PIC24FJ256DA210 Family Silicon Errata and Data Sheet Clarification

The PIC24FJ256DA210 family devices that you have received conform functionally to the current Device Data Sheet (DS39969B), except for the anomalies described in this document.

Data Sheet Clarifications

The following typographic corrections and clarifications are to be noted for the latest version of the device data sheet (DS39969B):

FIGURE 2-3 FREQUENCY vs. ESR PERFORMANCE FOR SUGGESTED VCAP

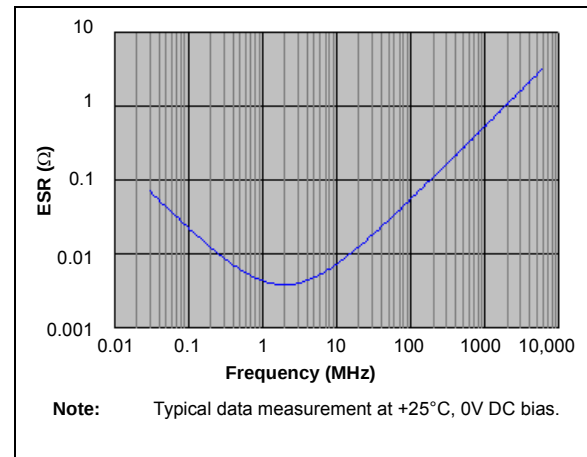
Section 2.4 “Voltage Regulator Pins (ENVREG/DISVREG and VCAP/VDDCORE)” has been replaced with a new and more detailed section. The entire text follows:

When the regulator is enabled, a low-ESR ($< 5\Omega$) capacitor is required on the VCAP pin to stabilize the voltage regulator output voltage. The VCAP pin must not be connected to VDD and must use a capacitor of 10 μF connected to ground. The type can be ceramic or tantalum. Suitable examples of capacitors are shown in [Table 2-1](#). Capacitors with equivalent specifications can be used.

Designers may use [Figure 2-3](#) to evaluate ESR equivalence of candidate devices.

The placement of this capacitor should be close to VCAP. It is recommended that the trace length not exceed 0.25 inch (6 mm). Refer to **Section 30.0 “Electrical Characteristics”** for additional information.

FIGURE 2-4 DC BIAS VOLTAGE vs. CAPACITANCE CHARACTERISTICS

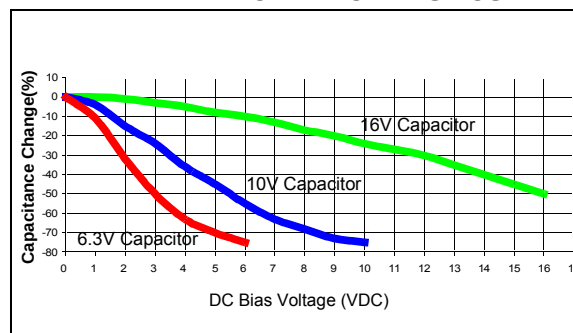
In addition to temperature tolerance, the effective capacitance of large value ceramic capacitors can vary substantially, based on the amount of DC voltage applied to the capacitor. This effect can be very significant, but is often overlooked or is not always documented.

A typical DC bias voltage vs. capacitance graph for 16V, 10V and 6.3V rated capacitors is shown in Figure 2-4.

When selecting a ceramic capacitor to be used with the internal voltage regulator, it is suggested to select a high-voltage rating, so that the operating voltage is a small percentage of the maximum rated capacitor voltage. For example, choose a ceramic capacitor rated at 16V for the 1.8V V_{CAP} voltage. Suggested capacitors are shown in Table 2-1.

FIGURE 30-1: PIC24FJ256DA210 FAMILY VOLTAGE-FREQUENCY GRAPH (INDUSTRIAL)

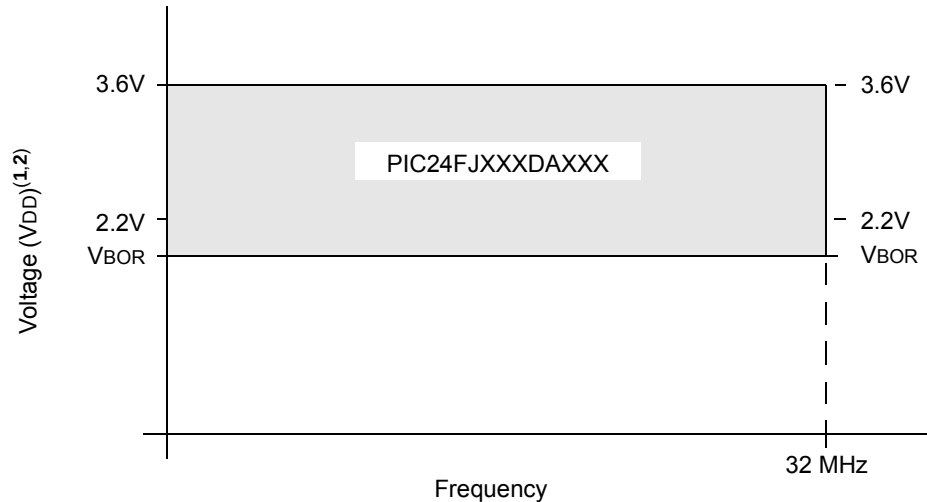
Figure 30-1 (“PIC24FJ256DA210 Family Voltage-Frequency Graph”) is amended by adding an additional footnote. The updated figure is shown below (changes in **bold**; bold in original removed for clarity).

Note 1: V_{CAP} (nominal On-Chip Regulator output voltage) = 1.8V.

2: When the USB module is enabled, V_{USB} should be provided at 3.0V to 3.6V. When the USB module is not enabled, the wider limits shaded in grey apply. The voltage on the V_{USB} pin should be maintained at (V_{DD} – 0.3V) or greater. Optionally, the pin may be left in a high-impedance state when the USB module is not in use, but doing so may result in higher I_{PD} currents than specified.
